UNITED STATES PATENT AND TRADEMARK OFFICE

10/549,720

Office Action Summary	Application No. 10/549,720	Applicant(s) WEIBERLE ET AL.	
	Examiner Melody M. Burch	Art Unit 3657

DETAILED ACTION

Fig. 4 *PRIOR ART*

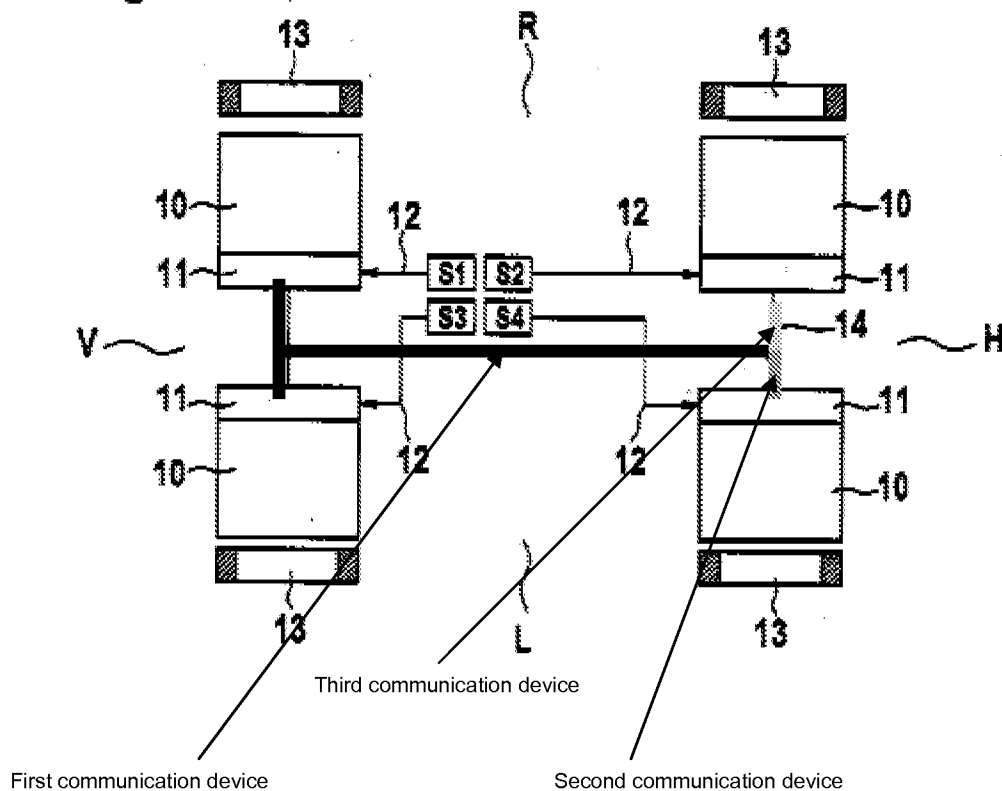
9. Claims 9, 10, 12, 13, 14, 15, and 16 are rejected under 35 U.S.C. 103(a) as being unpatentable over Admitted Prior Art figure 4 in view of US Patent 3693114 to Kempf.

Re: claims 9, 13, 14, 15, and 16. Admitted Prior Art figure 4 shows a decentralized electrical braking system comprising: at least four sensors S1-S4 for sensing an actuation of a brake actuating device; at least four wheel-braking modules 10, each wheel-braking module being assigned to a corresponding vehicle wheel and acquiring sensor data and controlling braking of the corresponding vehicle wheel; at least one first communication device as labeled on page 9 of the instant Office action connecting all four wheel-braking modules to one another by connecting to the labeled

second and third communication devices for exchange of data; an electrical connecting device 12 for connecting each sensor to at least one wheel-braking module; and at least one of a second communication device as labeled and a third communication device as labeled for facilitating at least one of receiving and exchanging data between at least two wheel-braking modules associated with opposite lateral sides of the vehicle, wherein the first, second and third communication devices are parts of the system, wherein a front wheel braking module of a first lateral side of the vehicle (upper left element 10) being connected only to a rear wheel braking module of a second lateral side of the vehicle (lower right element 10) by the second communication device via the first communication device and a front wheel braking module of the second lateral side (lower left element 10) of the vehicle being connected only to a rear wheel braking module of the first lateral side of the vehicle (upper right element 10) by the third communication device via the first communication device.

Admitted Prior Art figure 4 shows communication device parts meeting at a junction but is silent with regard to the first second and third communication devices being discrete.

It would have been obvious to one of ordinary skill in the art at the time the invention was made to have modified the first, second, and third communication devices of Admitted Prior Art figure 4 to have been discrete components, as taught by Kempf, in

Re: claims 10 and 12. Admitted Prior Art figure 4, as modified, teaches in prior art figure 4 the limitation wherein the at least one of the second communication device and the third communication device is configured identically to the first communication device in the form of a cable/wire, and each sensor is connected to two wheel braking modules associated with opposite lateral sides of the vehicle on the same axle via intervening elements such as portions of the communication devices.
